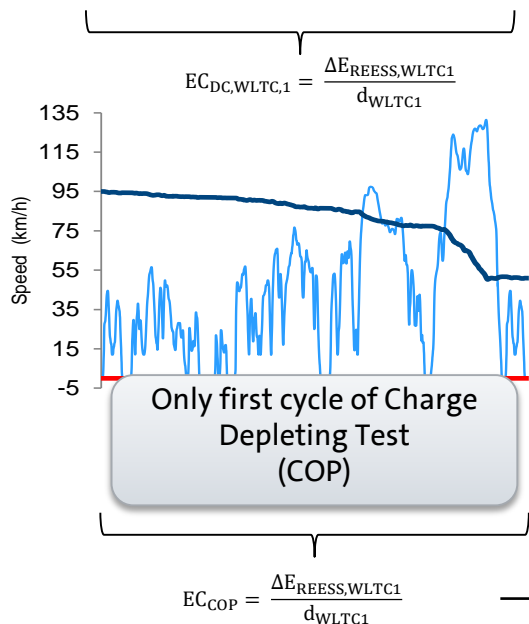
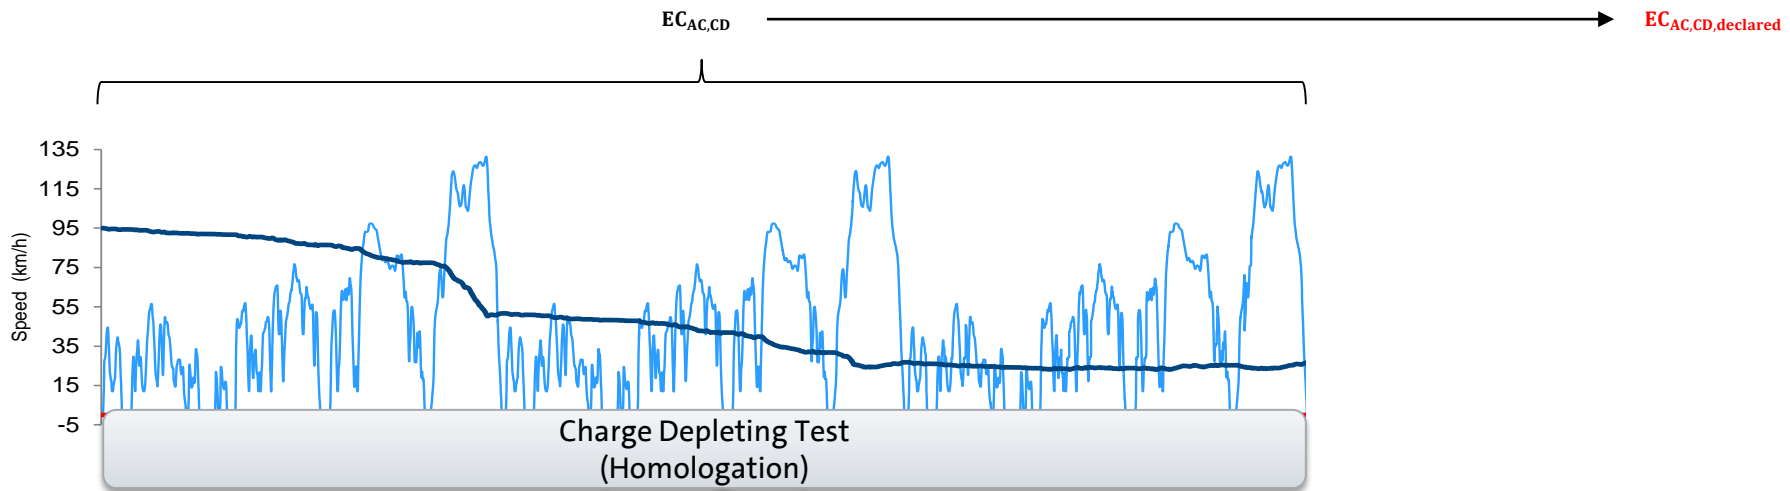
Remark:

$A_{FCO_2,CS}$ not necessary as after finishing all calculations,

the value for used for comparison in COP is always:

$M_{CO_2,CS,c,declared}$

→ Current text can be simplified

→ With and without $A_{FCO_2,CS}$: the result is the same

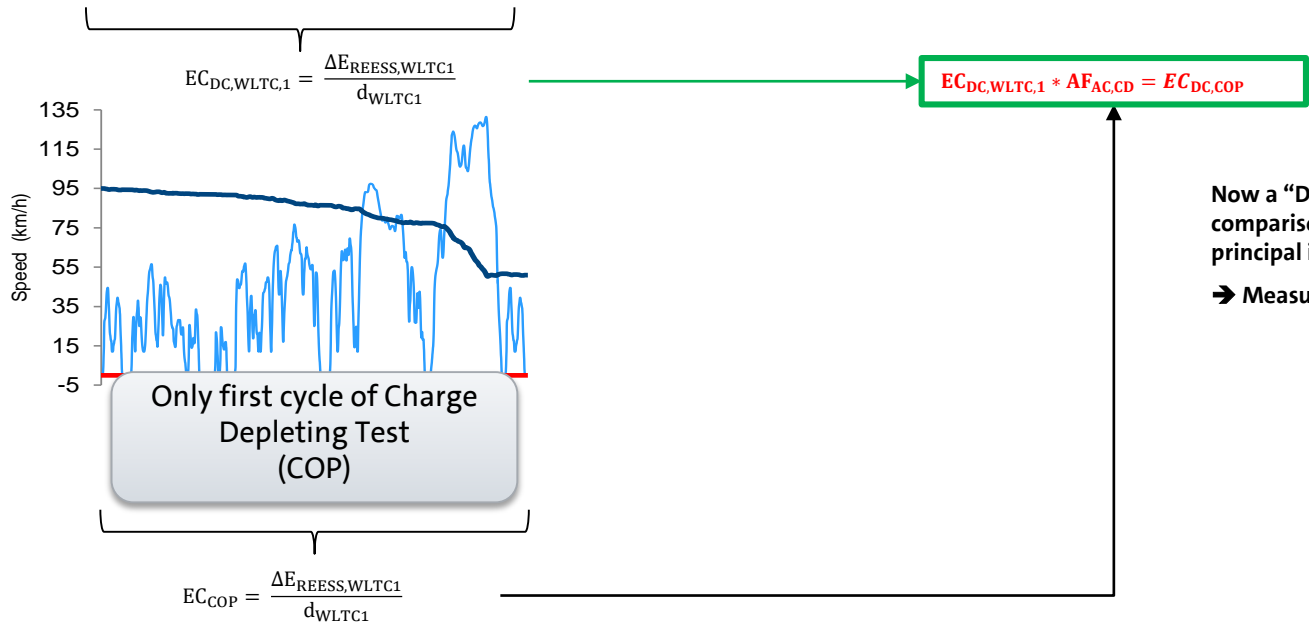
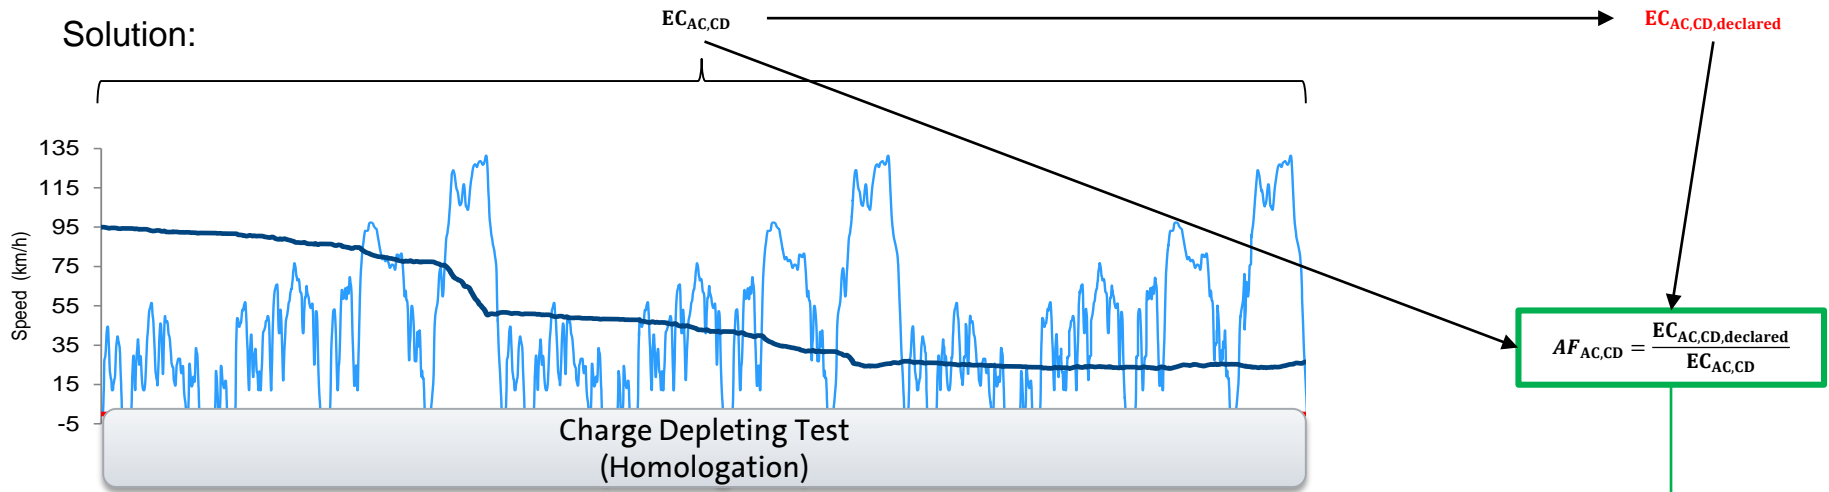
- $EC_{DC,WLTC,1}$ is a value especially created for COP to avoid a high mileage on customer vehicles
 - $EC_{DC,WLTC,1}$ is a measured value
 - For COP, there is no declared value available which can be used for comparison; measured COP value would need to be compared to the measured value
- unequal treatment
- Idea:
- Applying the „margin“ which is on the declared value " $EC_{AC,CD,declared}$ " to the value which has been created for the purposes of COP

Solution:

Now a "Declared" value available which can be used for comparison Conformity of Production value which follows the principal in the context of CS CO2
 → Measured COP value would be compared to a „declared“ value
